ADDENDUM NO. 01
January 13, 2022

To Drawings and Specifications dated December 17, 2021

CLINE ELEMENTARY SCHOOL CAMPUS REPLACEMENT
FOR FRIENDSWOOD I.S.D.

Prepared by: PBK
11 Greenway Plaza, 22nd Floor
Houston, TX 77046-1104
PBK Project No: 20380

GENERAL SUBGRADE
NOTES AND TYP
DETAILS - CONT

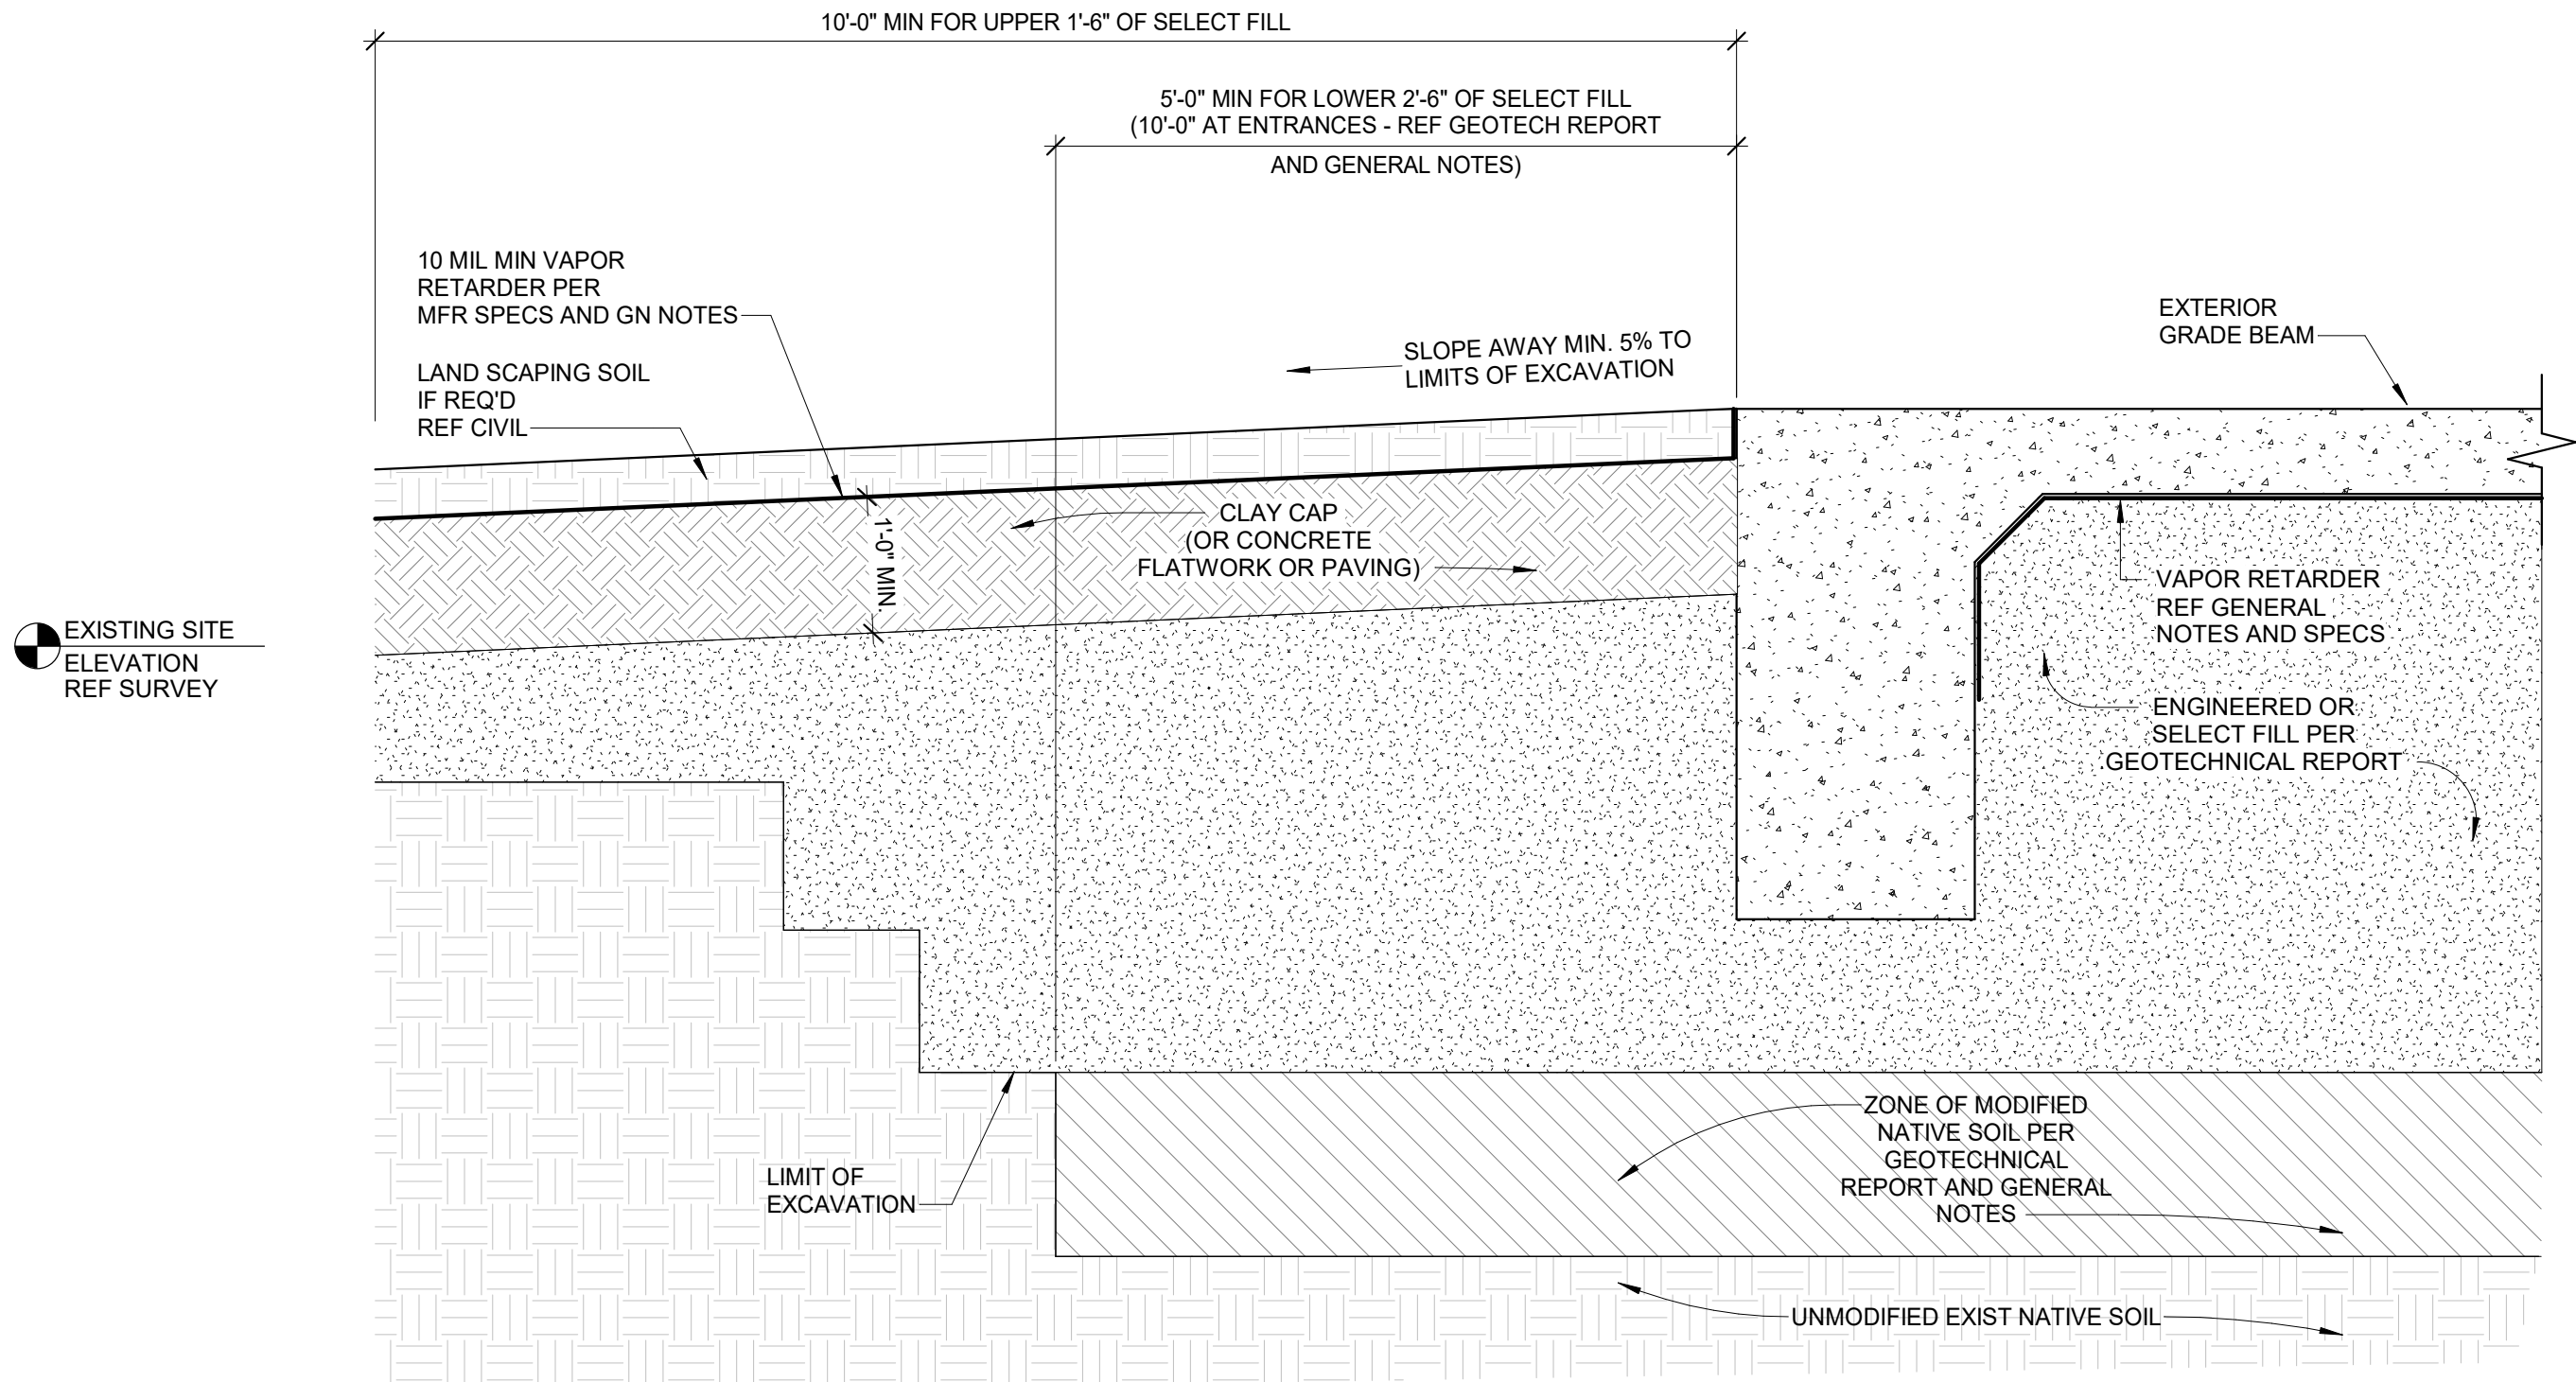
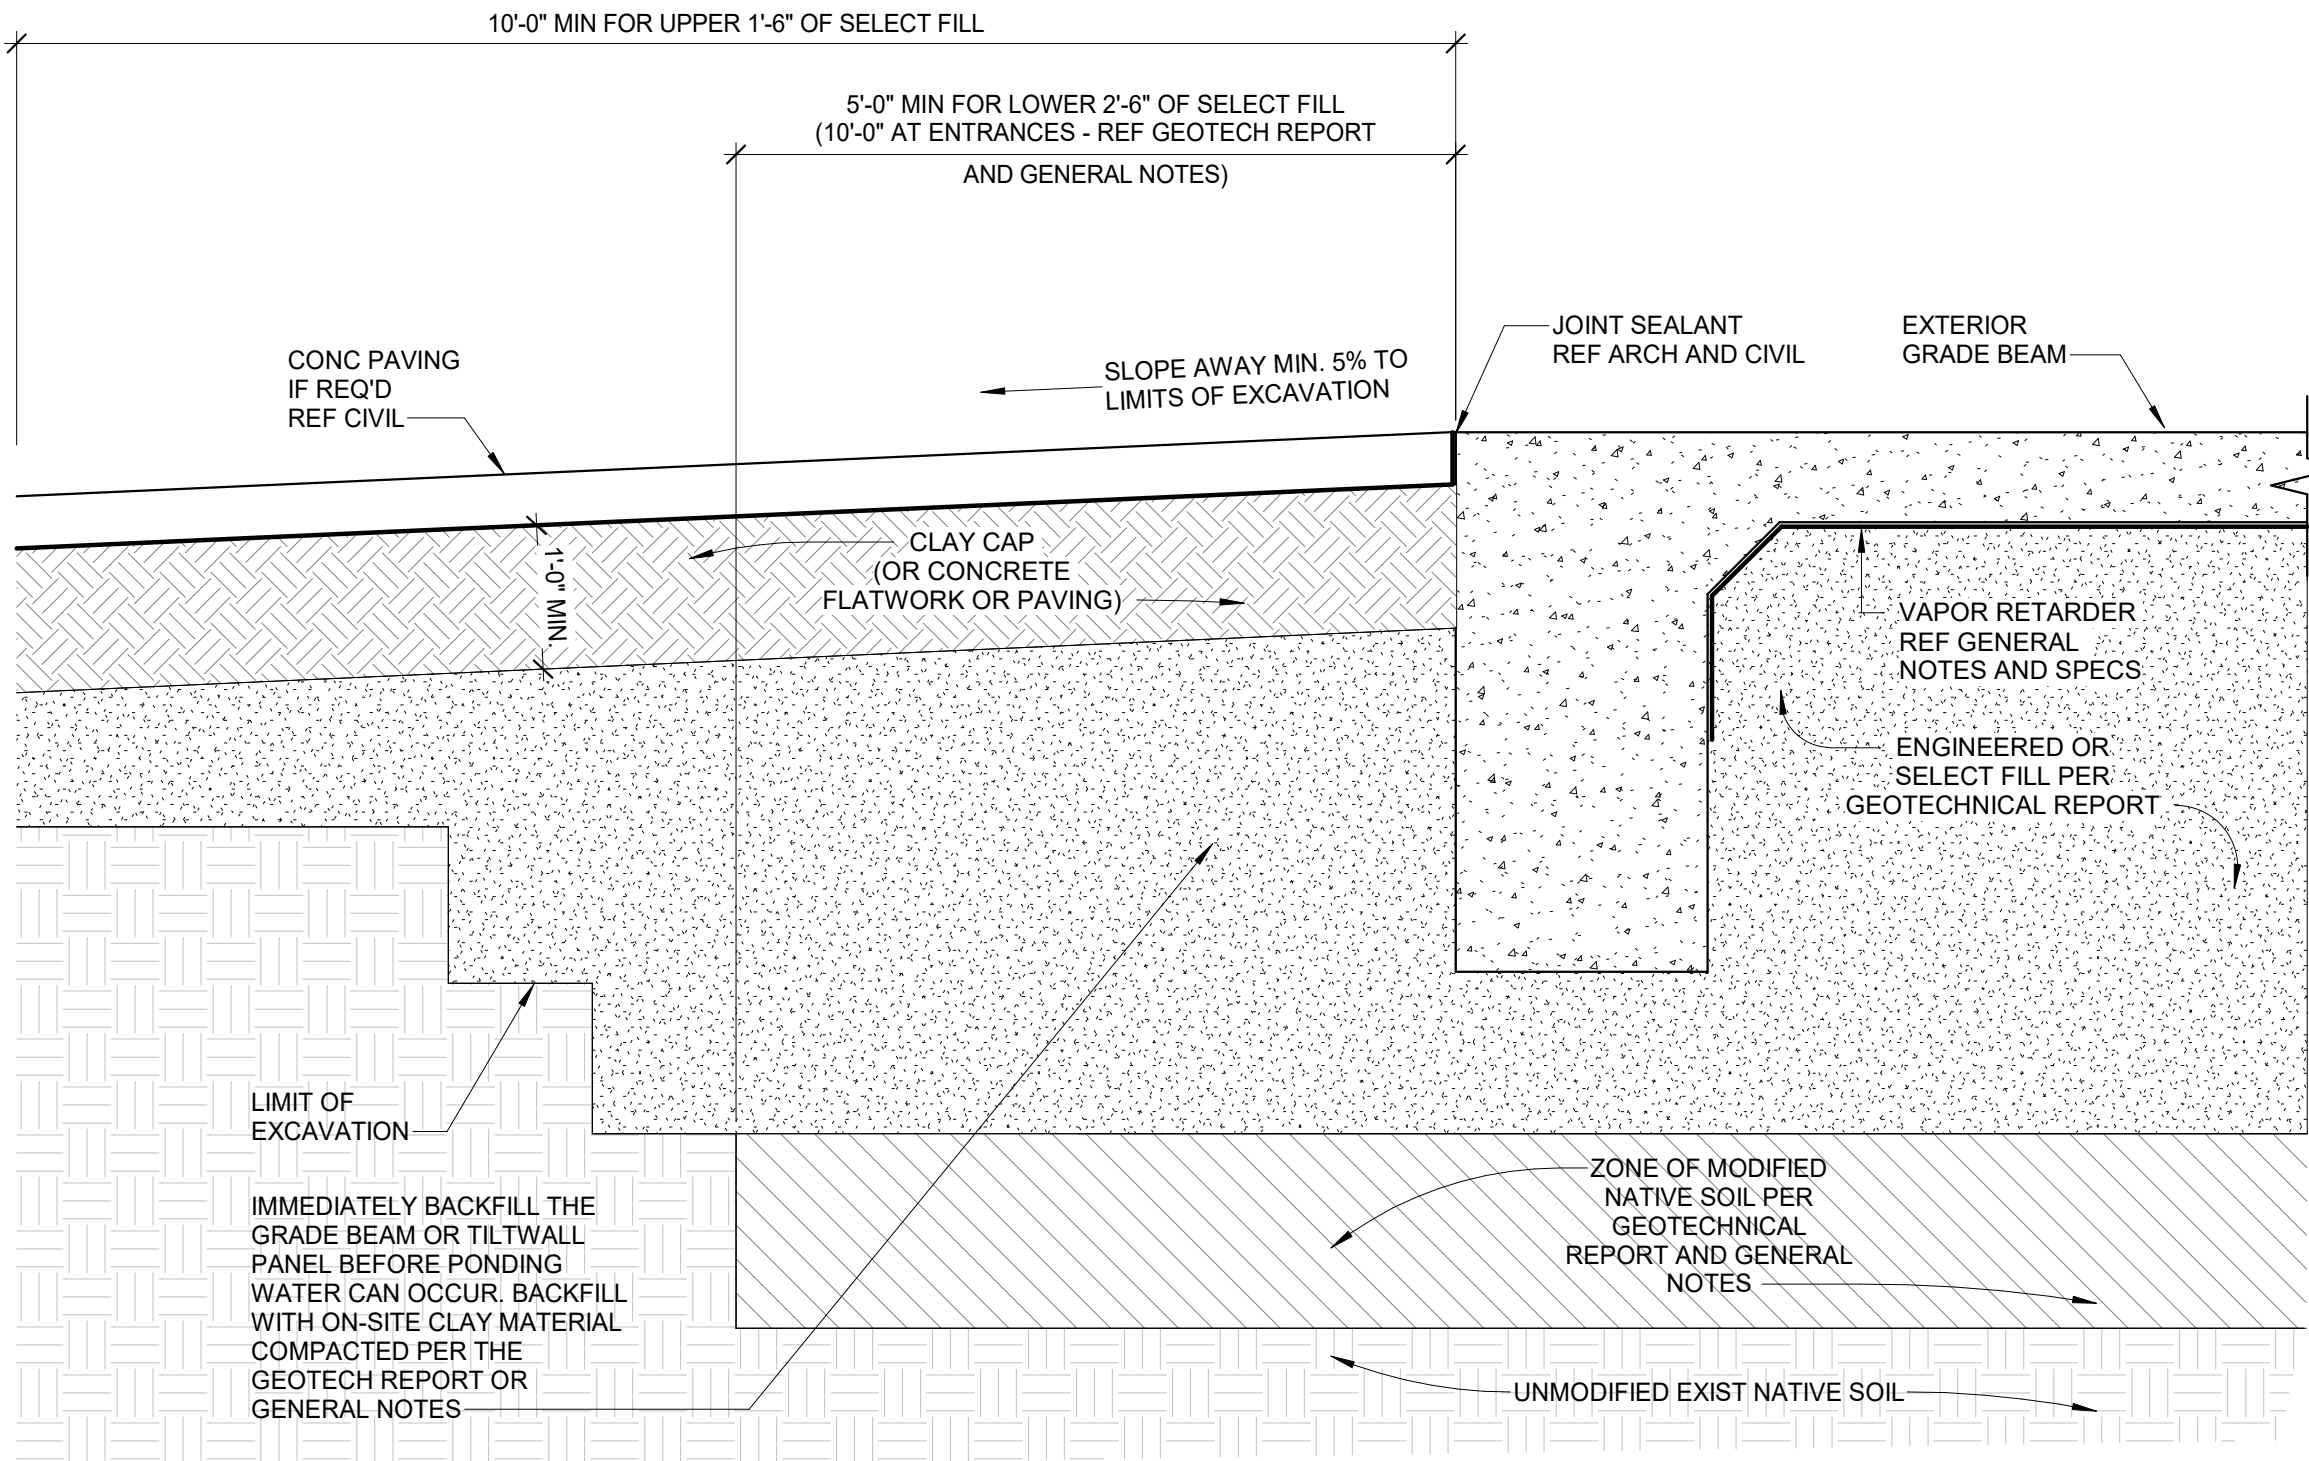
- a. Detail 1 revised. See revised sheet.
